BEFORE THE ARIZONA CORPORATION COMMISSION

7
 8 IN THE MATTER OF THE APPLICATION)
 OF CHEVELON BUTTE RE LLC, IN)
 CONFORMANCE WITH THE)
 9 REQUIREMENTS OF ARIZONA REVISED)
 STATUTES 40-360, ET SEQ., FOR A)
 10 CERTIFICATE OF ENVIRONMENTAL)
 COMPATIBILITY AUTHORIZING THE)
 11 CHEVELON BUTTE WIND GEN-TIE)
 PROJECT, WHICH INCLUDES THE)
 12 CONSTRUCTION OF A NEW 345KV)
 13 TRANSMISSION LINE AND ASSOCIATED)
 14 INTERCONNECTION FACILITIES)
 ORIGINATING IN COCONINO COUNTY)
 15 AND INTERCONNECTING WITH THE APS)
 16 PREACHER CANYON-CHOLLA 345KV)
 LINE IN NAVAJO COUNTY, ARIZONA.)

DECISION NO. 78388

**APPLICATION TO AMEND DECISION
NO. 77436**

EXHIBIT C

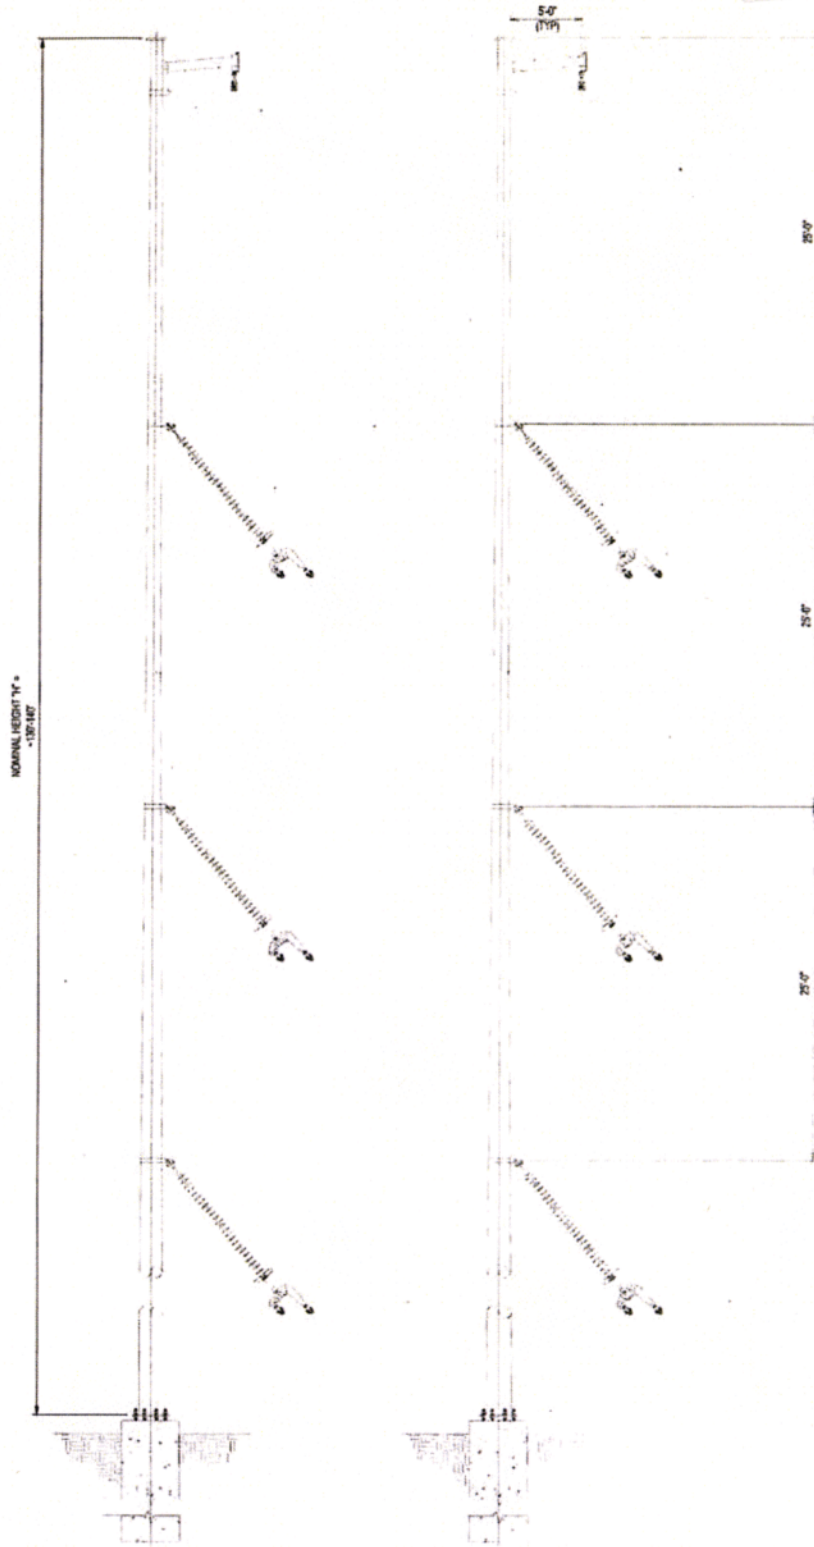
18 “(except for a one-mile segment, which will be a double-circuit 345
19 kV line in the area described in Condition 26)”

21 #26. Chevelon may construct the structures as depicted in Exhibit B up to 160 feet
22 above ground in the area shown in Exhibit C to this CEC. The segment of the line
23 depicted in Exhibit C will be constructed as a 345 kV double-circuit line.”
